Access Compliance Report

Public Rights-of-Way

(Curb Ramps)

Intersection ID: 17113	Main Street: STERLING_RD	Cross Street: WESTFIELD_RD	Location: SE
ADA ID: 188274422714	Ramp Type: Directional1	Initial Pass/Fail: Fail	Overall Compliance: No
Severity Score: 22.5			
Codes/Mitigation Info/Possible Solution		Field Measurements/Component Compliance

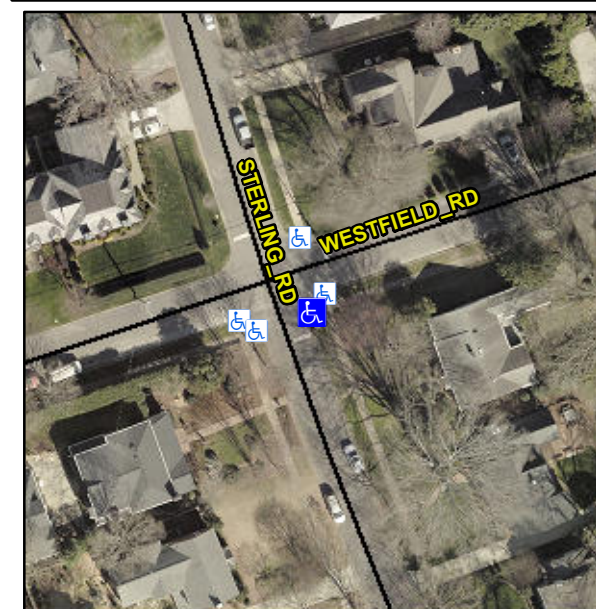
R304.5.1, R304.2.2, R304.5.3

Compliance	Description	Data	Compliance	Description	Data
N/A	Ramp Length (in)	61.0	N/A	Grade Break?	N/A
No	Ramp Width (in)	45.0	N/A	Grade Break Slope (%)	0.0
No	Ramp Slope (%)	9.9	N/A	Grade Break XSlope (%)	0.0
No	Ramp XSlope (%)	4.2			
N/A	Flare Type LT	N/A	N/A	Flare Type RT	N/A
N/A	Flare Slope LT (%)	N/A	N/A	Flare Slope RT (%)	0.0
N/A	Flare Traversable LT?	N/A	N/A	Flare Traversable RT?	N/A
N/A	Landing Length (in)	0.0	N/A	DWS Provided?	N/A
N/A	Landing Width (in)	0.0	N/A	DWS Contrast?	N/A
N/A	Landing Slope (%)	0.0	N/A	DWS Length (in)	N/A
N/A	Landing X Slope (%)	0.0	N/A	DWS Full Width?	N/A
N/A	Landing Curb? (Y/N)	N/A	N/A	DWS Offset LT (in)	N/A
N/A	Shared Landing?	N/A	N/A	DWS Offset RT (in)	N/A
N/A	Gutter Ponding?	0.0	N/A	Gutter Slope (%)	N/A
N/A	Gutter Lip Ht (in)	0.0	N/A	Gutter X Slope (%)	N/A
N/A	Painted X Walk1?	No		Road Slope (%)	0.2
	X Walk 1 Direction	To SW		Road X Slope (%)	2.8
	X Walk 1 Width (in)	N/A		Clear Space?	N/A

X Walk 1 Slope (%)	0.2	N/A	Clear Space to XWalk (in)	N/A
	X Walk 1 X Slope (%)	2.8	N/A	Storm Grate/Utility Hazard?	N/A
N/A	Ramp inside XWalk1?	N/A		Storm Grate/Utility Type	
N/A	Any Obstructions?	N/A			N/A
	Obstruction Type		Yes	Surface Condition? (G/P)	Good
			N/A	Curb Slope (%)	16.8

Remove & Replace Entire Ramp.
